### STAFF RECOMMENDATION 1102 Forrest Avenue January 18, 2017

**Application:** New construction-outbuilding  
**District:** Lockeland Springs-East End Neighborhood Conservation Zoning Overlay  
**Council District:** 06  
**Map and Parcel Number:** 08309012500  
**Applicant:** Jim O'Shea  
**Project Lead:** Robin Zeigler robin.zeigler@nashville.gov

**Description of Project:** The applicant proposes an addition to an existing non-historic out building, zoned CS.

Site Plan

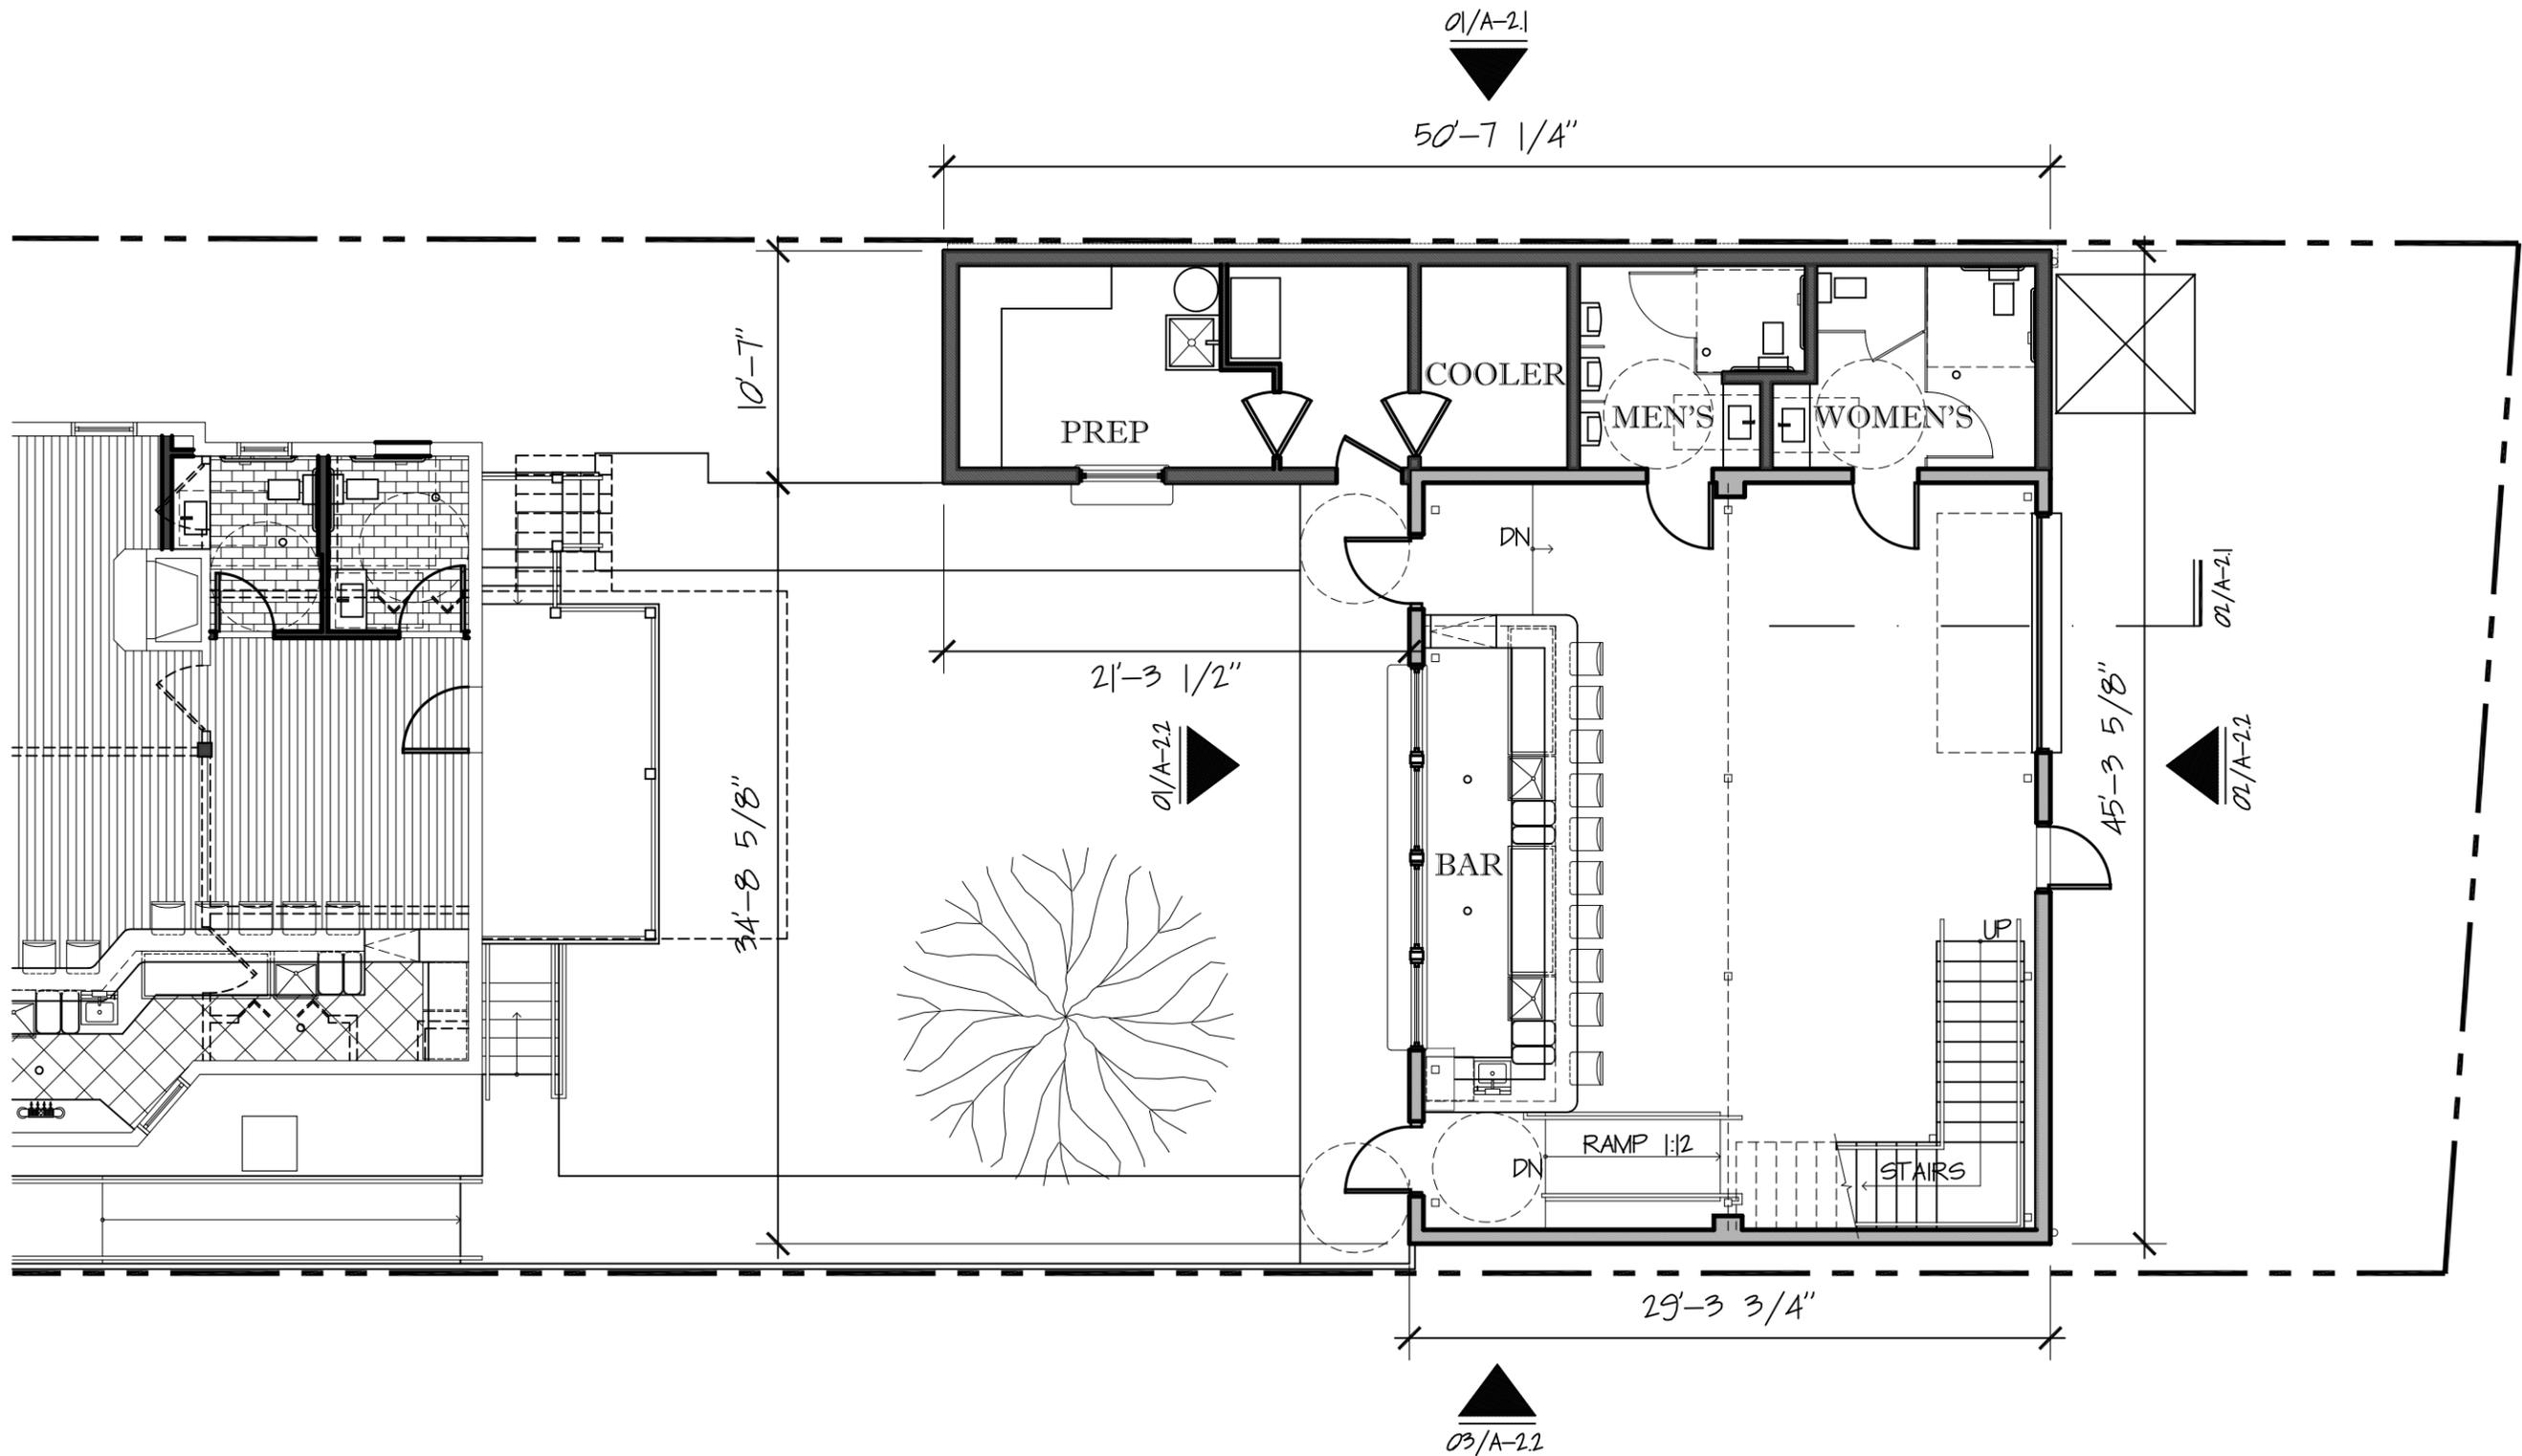
The policy for outbuildings is to allow for six hundred and eight square feet (608) for the footprint of a new outbuilding, which is 50% of the principle building's footprint. The existing outbuilding already exceeds that at one thousand and thirty-six square feet (1036 sq ft.) An additional five hundred and sixteen square foot (516 sq ft) footprint is proposed for a total of one thousand five hundred and fifty-two (1552 sq. ft.) square feet. Because the property is zoned CS, Staff recommends approval of the additional square footage of the outbuilding if any future additions to the historic building is capped at one hundred and twenty-five square feet (125 sq ft.).

The guidelines encourage outbuildings not to be wider than the principle building. In this case the principle building is thirty-three feet (33') wide at its widest point, the existing outbuilding is thirty-five feet wide (35') and the proposed will be forty-five feet (45') wide. Staff finds this to be appropriate because the property is zoned CS where bulk standards allow for zero setbacks. The guidelines also encourage that there be at least twenty feet (20') between the principle building and the outbuilding which the proposed meets.

Location: Outbuildings are required to be at the rear of the lot, which is the existing location for this project. The addition will not lessen the rear setback. The project meets II.B.8.b

Setback: CS zoning allows for 0 side setbacks. The right setback of one foot and four inches (1'4 1/8") is existing and will not change. The left setback will change from approximately ten feet (9' 11/8") to five inches (5"). No setback determination is required. The project meets section II.B.8.b.

With the condition that any future additions to the historic building not exceed one hundred and twenty-five feet (125 sq. ft.) staff finds the project meets section II.B.8.a.

01 East Elevation

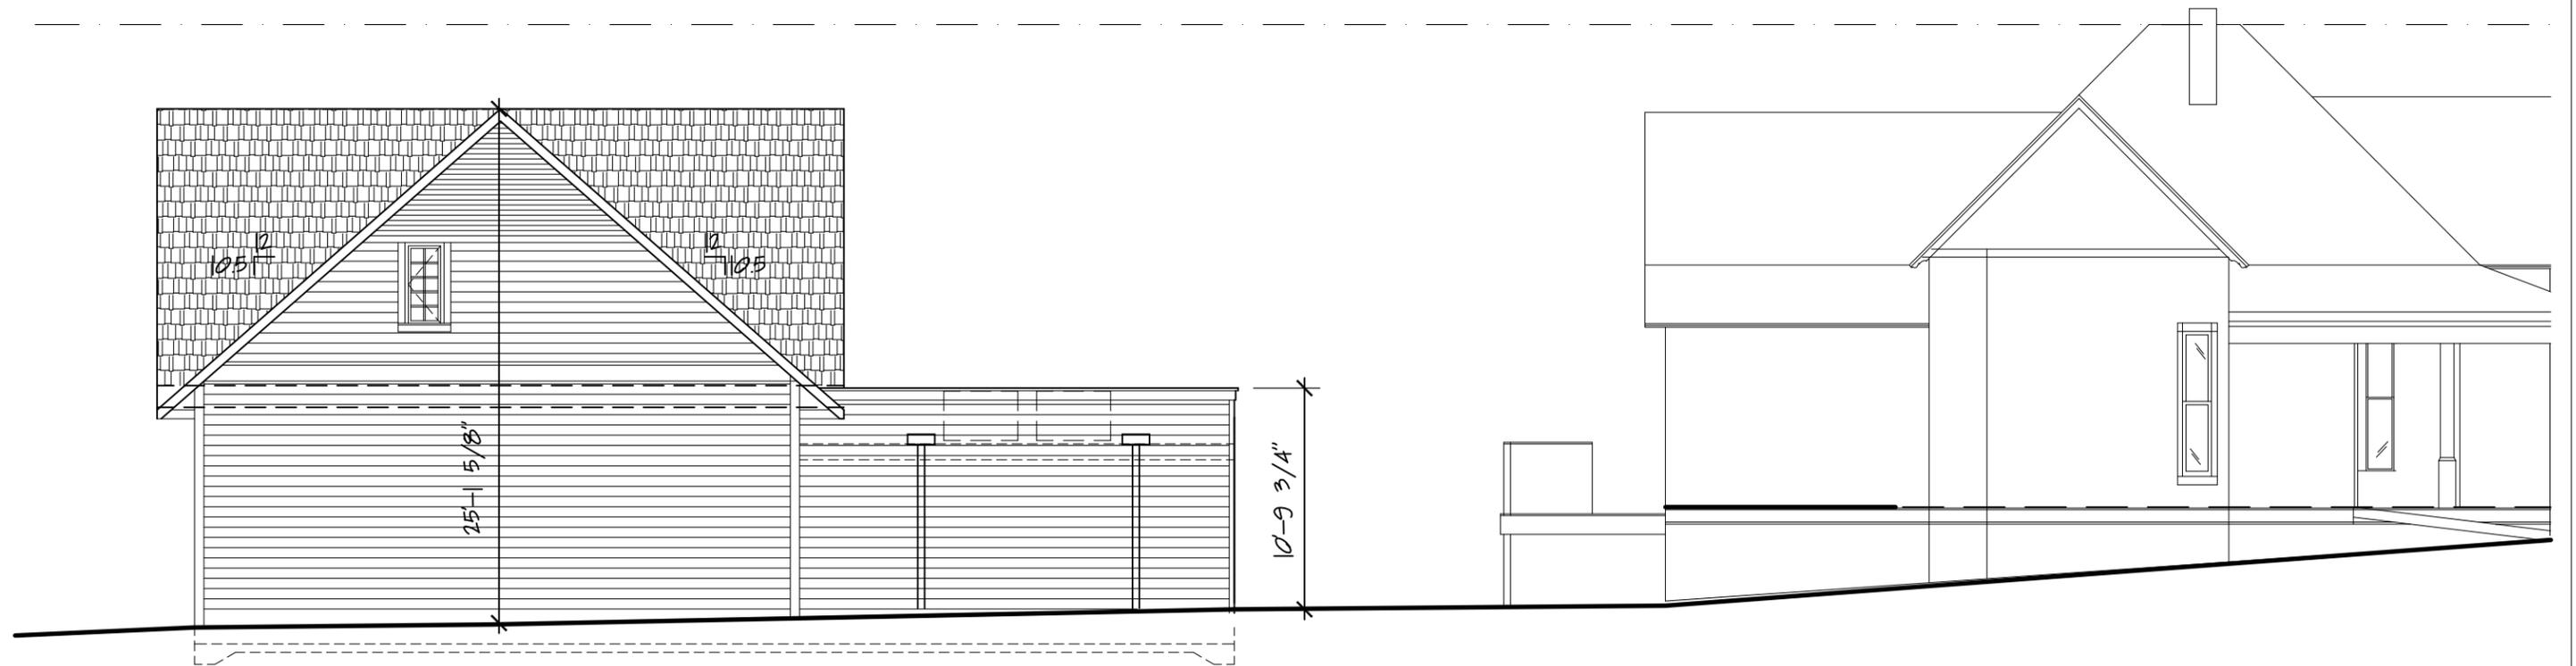
The new height of the outbuilding will be twenty-five feet, seven and three-eighths inches (25' 7 3/8"). It will be subordinate to the principle building which is twenty-six feet and four and one half inches (26' 4 1/2") tall. The eave height will be ten feet and two and one half inches (10' 2 1/2") tall compared to the twelve feet five and five-eighths inches (12' 5 5/8") of the principle building. Typically, outbuildings should not exceed twenty-four feet in (24') height with eaves that are less than the existing house and should not exceed the number of stories of the principle building, which is one-story. Because of the large footprint, the desire to have a roof pitch similar to the existing, the fact that the building will still be subordinate to the principle building, and the CS zoning, staff recommends approval of the additional height.

Roof form: The proposed roof form is cross-gable with a flat portion. Both forms are typical for the district. The pitch of the cross-gable is 10.5/12 which is similar to the 12/12 of the historic building. The roof form includes skylights. Staff recommends a

condition that the skylights be flat to the roof and not have a bubble form. The project meets section II.B.8.a.
